HCSA Rev F release package

The facility taken apart, every flight part drawn and in 3D, the test pieces with their shop drawings and STEP files, what the computer tests found, and what is still open.

For	Marco Cross, fabrication and feasibility review, Tuesday 17 November 2026, 10:00, and Rick Fleeter
From	Manos Theofanous and the HCSA team
Date	13 November 2026
Replaces	The Master Document of 27 October 2026 (Rev E)
Status	Working baseline. Nothing in it is released for manufacture; the test pieces are for quotation

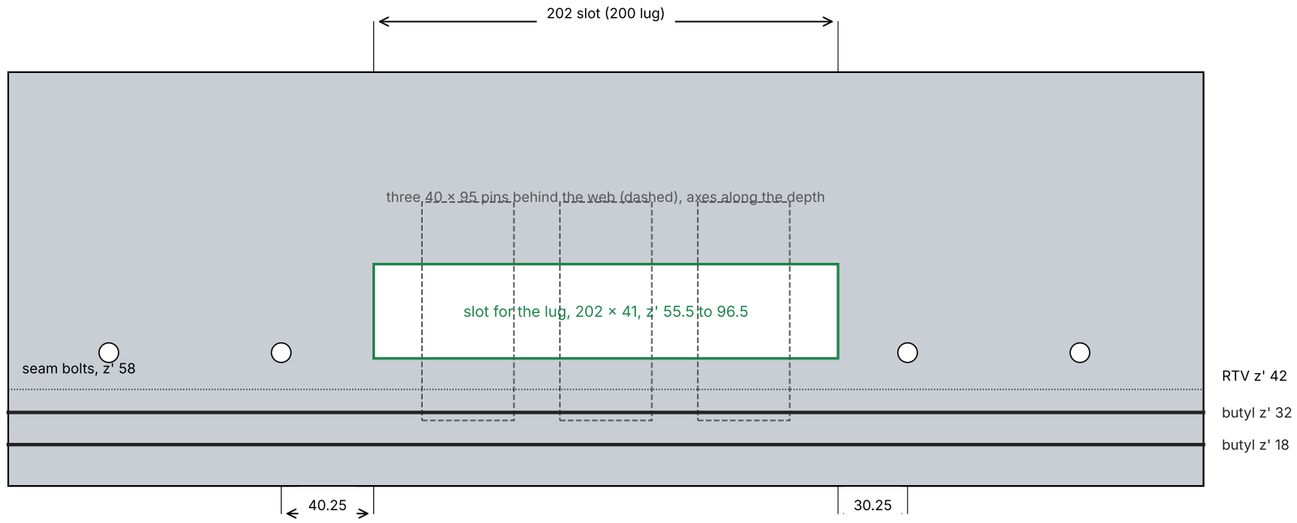
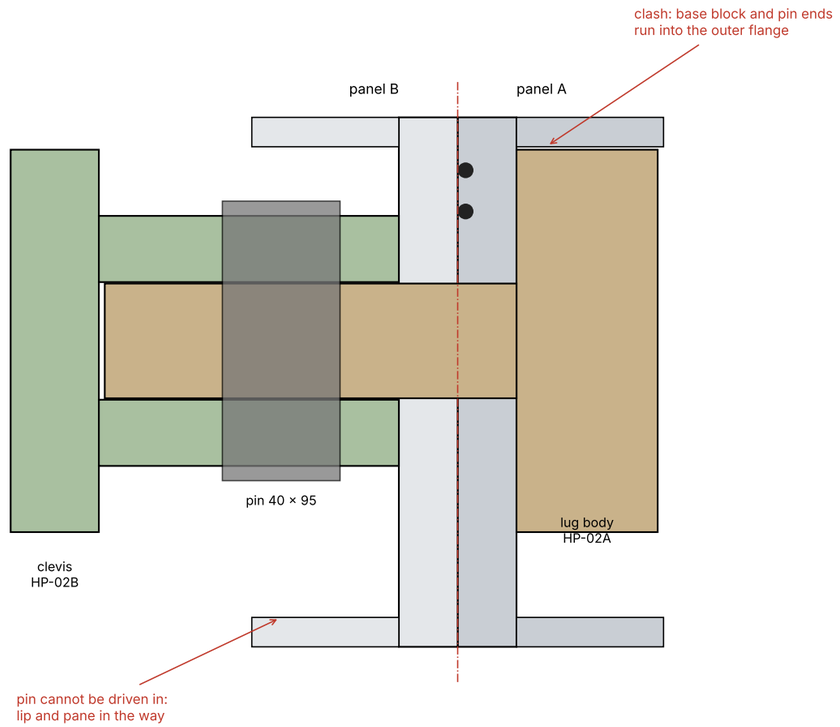
4. **The hardpoint position is right and the hardpoint part is not yet a design.** The fitting in the October model is a 39 mm titanium lug on one panel reaching into a two-

cheek clevis on the other, with three 40 mm pins along the panel depth in double shear. Our 8 November solids had the pins crossing the joint, which was wrong, and the clash we reported with the seam bolts came from a bolt drawn in the wrong place. With the real part at the moved position, only the lug crosses the joint, through a slot that is 10.5 mm from the RTV recess, 20 mm from the inner gland and clear of the seam bolts. That much works. What does not: the bodies had to move 38 mm apart to sit behind the 20 mm webs, so the lug is longer and the October stiffness no longer applies; the base blocks and pin ends run into the outer flange and into the two secondary ribs that land there; the pins cannot be driven in past the seat lip and the pane; and nothing says how the base blocks fasten to the frame. Sheet RF-07 shows all of it. The fitting has to be redrawn for the 180 mm frame and both models rerun.

What the models say (HP1, 6-7 Nov). With the fitting where sheet RE-06-1 put it, 64 mm deeper than the line of the pull, the frames hinge about it and the seal gap reaches 0.11 mm at 0.22 atm (0.47 with the frames held) against the 1.93 atm required. With it on the line of the pull (lug mid-plane at z' 76) the gap at the hardpoint is 0.064 mm at 1.93 atm; the band at the plain bolt beside it reaches 0.11 mm at 1.87 atm, 3 % short. Runs with that bolt closer (115 mm) and tighter (6 kN) are on the laptop, 9 Nov. Those runs model the fitting as a spring between rigid pads of 200 × 60, not this part.

The independent check on 9 November found that our 8 November hardpoint solids were wrong, and recovering the real fitting from the October model showed it does not fit the 180 mm frame. That is set out on sheet RF-07 and in part 2, and it is question 5 for the call.

to 0.5 atm; moved onto the line of the pull the seal at the fitting holds to 2.5 atm, with the bolt beside it 3 percent short of its requirement, and Rick agreed that move on 10 November.

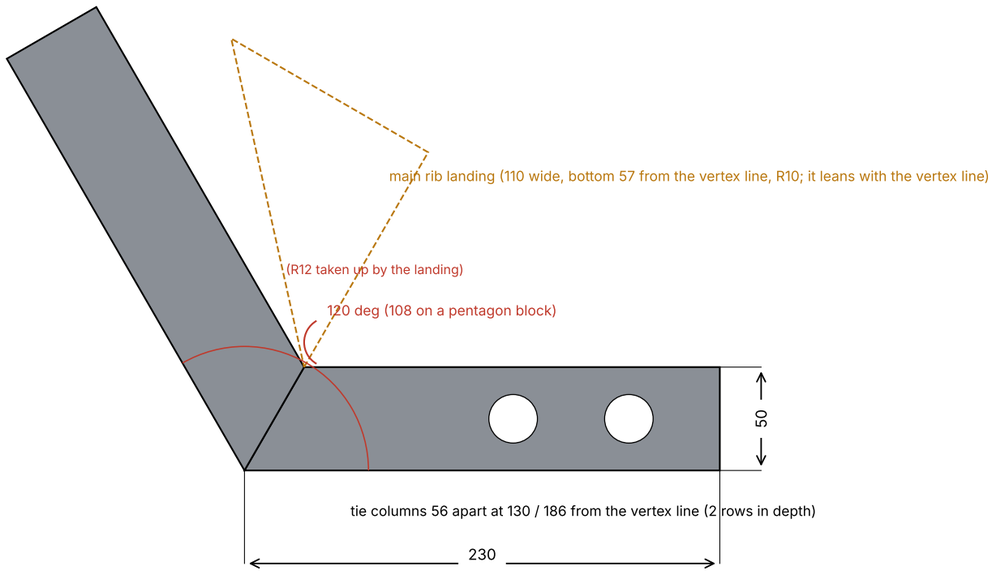
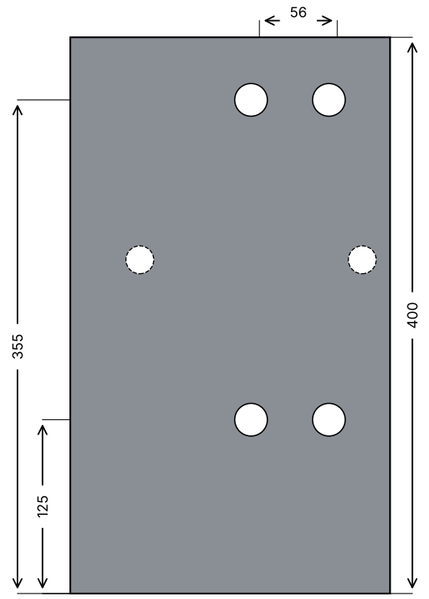
Corner node, machinability **(Marco)**	Marco: as drawn it cannot be machined; inside corners need radii an end mill can cut; it could be cast, which may change the material. Also the tie-to-fillet clash (Q29), the O10 corner seal section (Q27), the units on Heintges' 4-6 lap (Q28), and the way the main rib flanges enter the block	Manos with Marco, 17 Nov; Fusion	RE-06-2, T3

1. The corner block is machined from plate, not cast and not die forged (RF-08, CB-01). It carries seal loops on two faces, and a casting's porosity is a leak path there; there are only 180 blocks, too few for a die. Cut from a billet it starts at 87 kg and ends at 23 kg. Every surface is a plane or an R10 corner parallel to one line, so one set-up on a rotary axis does the faces, the landing and the holes. The R10 corners are 430 mm long and have to be cut from the open side. The weak spots are the 17 to 20 mm of metal between the rib landing and the joint face, and a washer seat 3.4 mm from the landing edge on the pentagon block.

The block weighs 22.9 kg with its leaning faces. Cut from a 2219 or 7050 billet sawn along the lean it starts at about 95 kg, so three quarters is chips. That sounds wasteful and is still the right answer, for three reasons.

- The block carries seal loops on two faces. A casting has porosity, and porosity on a sealing face is a leak path. A casting also carries a casting factor on its strength, 1.25 or more, on a part that is already near its limit.
- A forging needs a die. There are 180 blocks on the station, 120 of one kind and 60 of the other, and a die does not pay for that number. A hand forging is only a better billet.
- Plate in 7050-T7451 is made thick with its strength guaranteed through the thickness, so the 400 mm depth would be cut along the plate, not through it. Every surface of the block is a plane or an R10 corner parallel to the vertex line, which suits one set-up on a rotary axis.

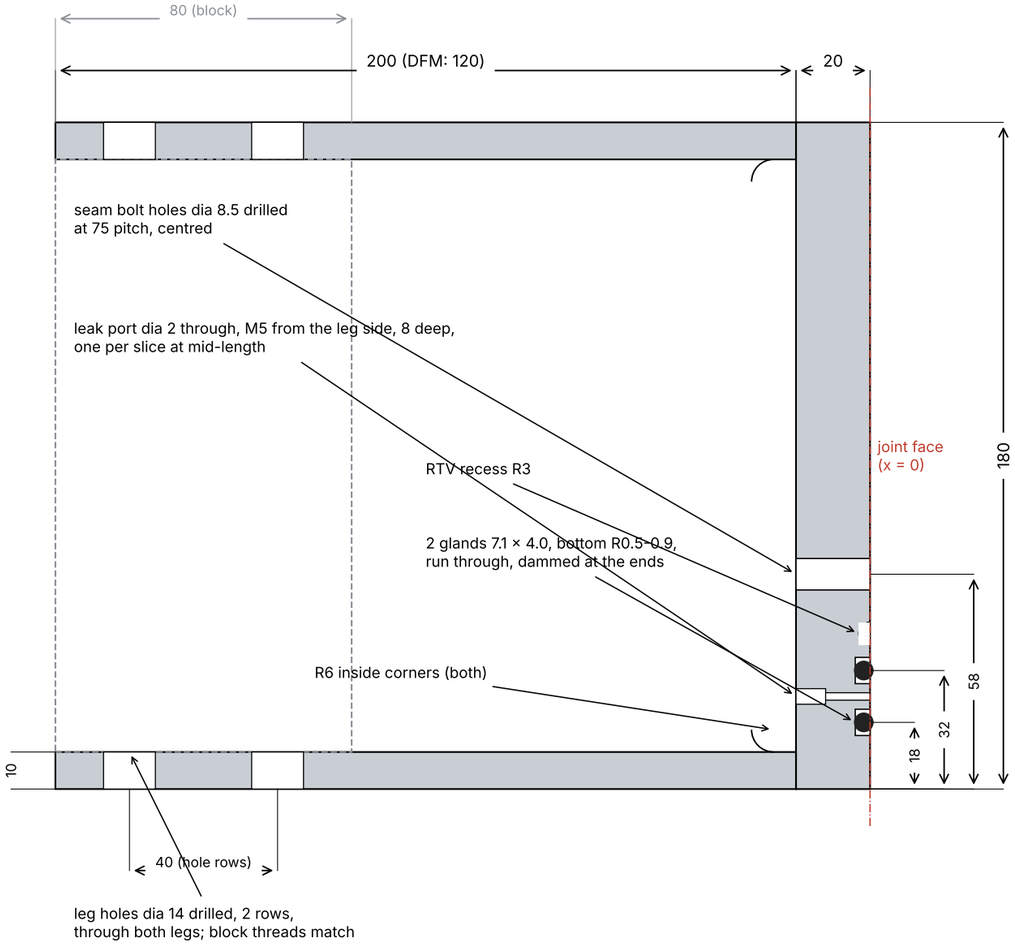
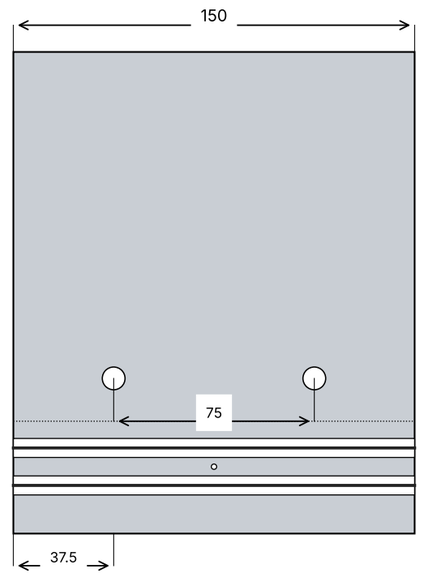
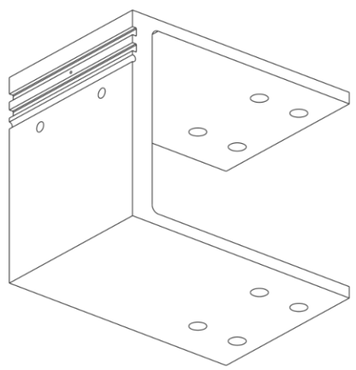
3. Only two features are tight on the test pieces (TP-00). The gland depth, plus or minus 0.05, and the joint face flatness, 0.10 over 150 mm and 0.15 over 550. They are the only two that change the squeeze on the cord, which stays above 16 percent in the worst stack. Everything else is ordinary shop tolerance, lengths measured at 20 degrees. Hardware for the test pieces comes from McMaster.

7. Holding frame B to cut the glands and the joint face in one setting. That is the fixturing question behind the flatness, and it is the machinist's, so we would like your view before the drawings go to Xometry.

So going from 0.05 to 0.10 mm flatness costs two points of squeeze, and the seal still has 16 percent in the worst stack. Going to 0.20 would not be safe without Parker's word on the minimum. That is the case for the split on sheet TP-00: the gland depth (plus or minus 0.05) and the joint face flatness (0.10 over 150 mm) are the only two tight features, because they are the only two in this sum. Everything else on the frame, the bolt holes, the leg holes, the length, the flange, can be ordinary shop tolerance, since none of it changes the squeeze.

Marco suggested 7000-series aluminium. For the test pieces the answer is still 6061-T651: they are only pulled, the load is low, every shop stocks it, and T651 plate is stretched, so it moves least when it is cut. The way to keep it flat is in the cutting order, not the alloy: rough both sides, let it rest, then finish the joint face and the glands in one setting.
